AMENDMENT OF SOLICITATION/MODIFICATION OF CONTRACT				1. CONTRACT ID CODE	PAGE 1 OF 3 PAGES
2. AMENDMENT/MODIFICATION NO. AMENDMENT NO. 0004		3. EFFECTIVE DATE 07/30/14	4. REQUISITION/PURCHASE REQ. NO.	5. PROJECT NO. (If applicable) 13-0047	
6. ISSUED BY Officer in Charge of Construction MCI-East 1005 Michael Road Camp Lejeune, NC 28547-2521		CODE mks	7. ADMINISTERED BY (If other than Item 6) See Item 6		
8. NAME AND ADDRESS OF CONTRACTOR (No., street, county, State and ZIP Code)				(X)	9A. AMENDMENT OF SOLICITATION NO. N40085-13-R-0047
				X	9B. DATED (SEE ITEM 11) 07/17/14
					10A. MODIFICATION OF CONTRACT/ORDER NO.
					10B. DATED (SEE ITEM 11)
CODE		FACILITY CODE

13-0047 Install Modular Dispensary Facilities, "L" Street and "F" Street, Hadnot Point

A DISPENSARY - SITE GRADING PLAN
 C-2(C-2) SCALE: 1" = 20'

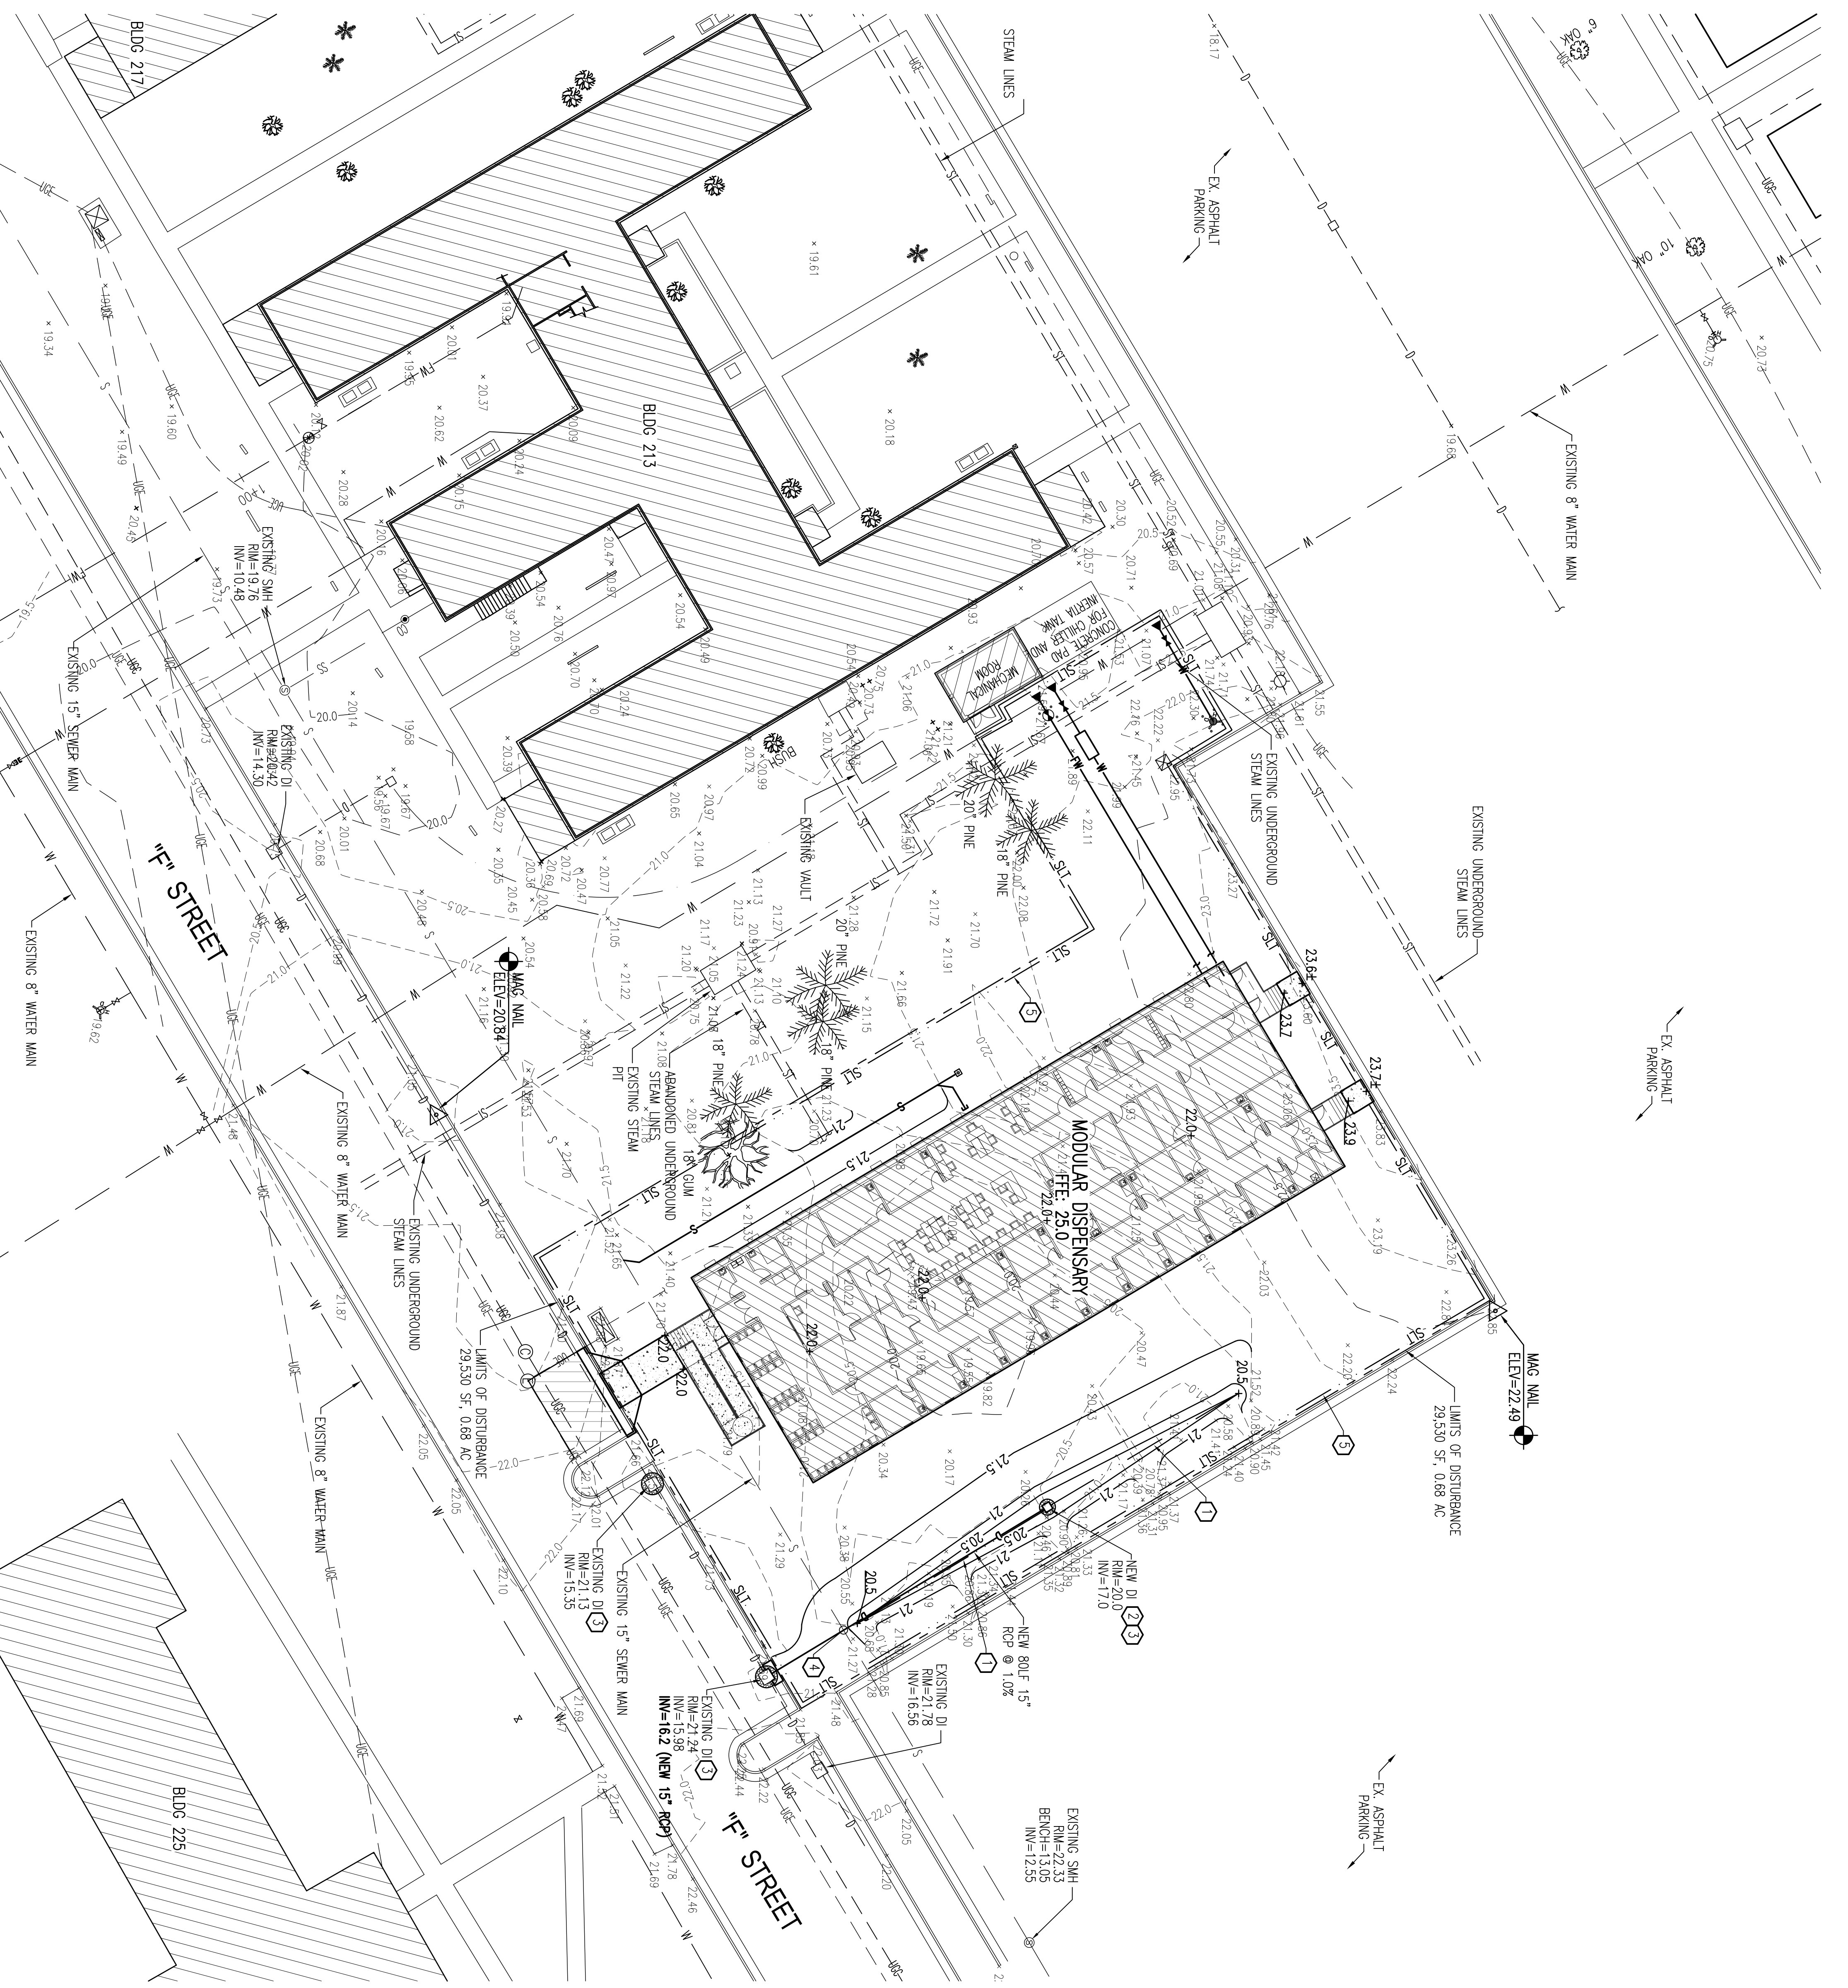
1. Question: During the review of the new site elevations to be provided at the "F" street it is noted that a clearance issue occurs under the north end of the modular dispensary. Existing elevations above 22.0' will likely prevent the 18" of clearance required by code under the building framing. Also the flatness of the filled area at 21.5' under and about the modular dispensary does not provide the recommended drainage away from the building. If water stands under the building or the clearance under the frames is restricted, the warranty will be voided. Please find suggested minor elevation and topo line changes to DWG C-2 to correct both concerns noted above. It is requested consideration be given to modifying the contract site work to provide the elevations submitted.

At "L" site the required FFE for the modular dispensary is given as 34.5' and the site elevations are in the 19' to 20' range. Should the required FFE for the Modular Dispensary to be revised to 24.5'?

F Street:

1. See attached Site Grading Plan. Spot elevations have been added to clarify extent of filling.
2. Install Modular to elevations shown.

L Street:

1. At L Street, FFE is stated as +34.5" above Finish Grade, not 34.5' of elevation.
